**INSTALLATION OF THE NEW ICEMAKER PART NO. 17098023 ON SIDE BY SIDE
REFRIGERATORS - Rev. 01**

As from serial no. 714xxxxxx (complete no. 4A714xxxxxx), the appliances listed in tab. A, are equipped with an old icemaker part no. 2416965032 or 2416965024 or 2416277024.

The mentioned icemaker has been replaced by the new one part no. 2417098023 and has a number of improvements over the previous one:

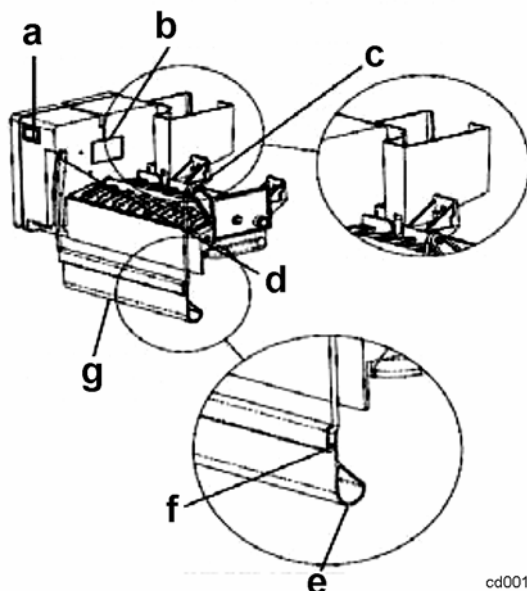
- The lifting of the bail arm is controlled in the head of the icemaker rather than from on the end of the ejector arm.
- The extension for the bail arm has been modified to give a wider surface to sit on the ice cubes.

The part no. for the bail arm is 2417206014 and is included in the icemaker.

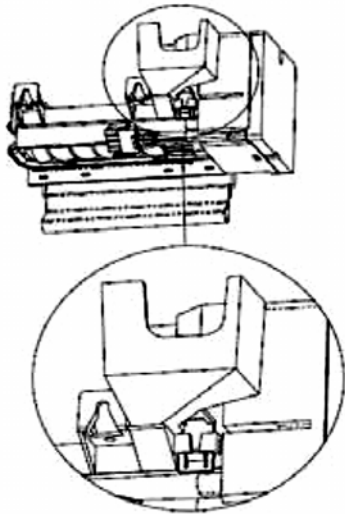
- a – ON/OFF switch
- b – label location
- c – bail arm right side support
- d – lift for bail arm
- e – wide edge towards the bottom
- f – top edge towards the front
- g – new bail arm extension

1. Install the bail arm extension in the icemaker.
Both edges e) and f) must be placed correctly as shown in the figure above so that the extension can fold to the back when the bucket is installed.
Push the extension on until it clicks against the bail arm.
